SK 0.02

ELEV: RELOCATED TREE
ROANOKE ISLAND FESTIVAL PARK
Wayfinding, Visitor Center & Museum Improvements

SC: 1/4" = 1'-0"
DATE: 18 JAN 2013

1 ELEVATION: RELOCATED EXISTING FAUX TREE
SCALE: 1/4" = 1'-0"

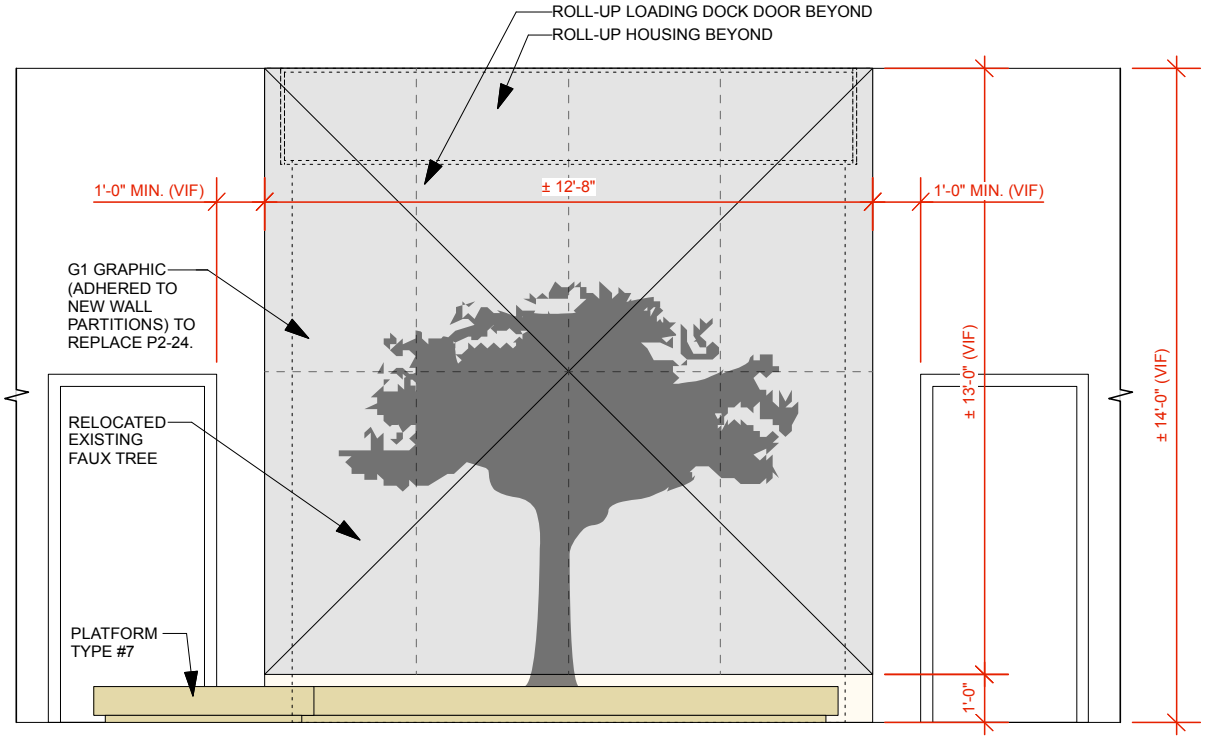
1. PROVIDE NEW ±14'-0"H (VIF) WALL PARTITION TYPE 'C' TO CONCEAL ROLL-UP LOADING DOCK DOOR AND TO PROVIDE ADDITIONAL SUPPORT FOR FAUX TREE. ATTACH NEW PLATFORM TYPE #7 TO NEW WALL PARTITION AS REQ'D.

2. REPLACE GRAPHIC P2-24 WITH NEW G1 GRAPHIC, ADHERED TO NEW ±14'-0"H (VIF) WALL PARTITION WITH VHB TAPE AS REQ'D.

3. RELOCATE EXISTING FAUX TREE ONTO NEW PLATFORM TYPE #7. TIE-BACK TREE INTO NEW WALL PARTITION TYPE 'C' AND NEW PLATFORM TYPE #7 AS REQ'D FOR ADDITIONAL SUPPORT. IF NECESSARY, PROVIDE AIRCRAFT CABLE TIED BACK TO CEILING FOR ADDITIONAL SUPPORT.
